Access Compliance Report

(Curb Ramps)

Intersection ID: 48451	Main Street: RED_RUST_LN	Cross Street: DANCING_WIND_RD	Location: NE
ADA ID: BA377583FAFF	Ramp Type: Perp	Initial Pass/Fail: Fail	Overall Compliance: No
Severity Score: 8.75			
Codes/Mitigation Info/Possible Solution		Field Measurements/Component Compliance

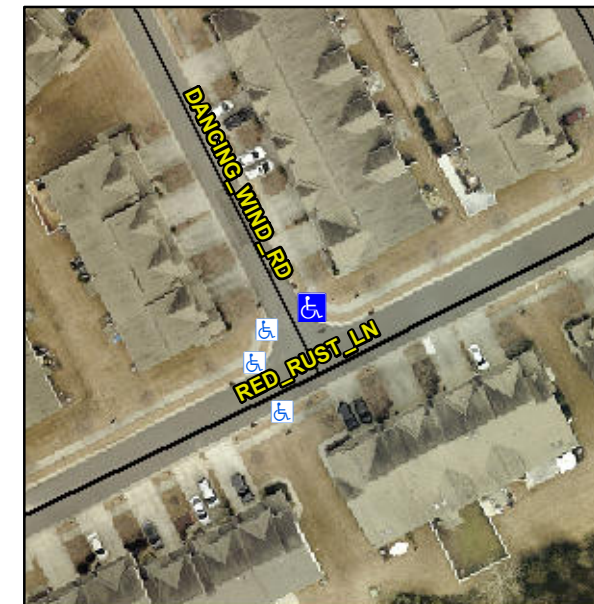
Not Found, R304.5.1

Compliance	Description	Data	Compliance	Description	Data
N/A	Ramp Length (in)	47.0	Yes	Ramp Slope (%)	5.3
No	Ramp Width (in)	47.0	Yes	Ramp XSlope (%)	1.1
N/A	Flare Type LT	N/A	N/A	Flare Type RT	N/A
N/A	Flare Slope LT (%)	N/A	N/A	Flare Slope RT (%)	N/A
N/A	Flare Traversable LT?	N/A	N/A	Flare Traversable RT?	N/A
N/A	Landing Length (in)	N/A	N/A	DWS Provided?	N/A
N/A	Landing Width (in)	N/A	N/A	DWS Contrast?	N/A
N/A	Landing Slope (%)	N/A	N/A	DWS Length (in)	N/A
N/A	Landing X Slope (%)	N/A	N/A	DWS Full Width?	N/A
N/A	Landing Curb? (Y/N)	N/A	N/A	DWS Offset (in)	N/A
N/A	Shared Landing?	N/A			
N/A	Gutter Ponding?	N/A	N/A	Gutter Slope (%)	N/A
N/A	Gutter Lip Ht (in)	N/A	N/A	Gutter X Slope (%)	N/A
N/A	Painted X Walk1?	No	N/A	Painted X Walk2?	N/A
	X Walk 1 Direction	To SW		X Walk 2 Direction	N/A
N/A	X Walk 1 Width (in)	N/A	N/A	X Walk 2 Width (in)	N/A
	X Walk 1 Slope (%)	0.3		X Walk 2 Slope (%)	N/A
	X Walk 1 X Slope (%)	0.2		X Walk 2 X Slope (%)	N/A

Remove & Replace Entire Ramp.
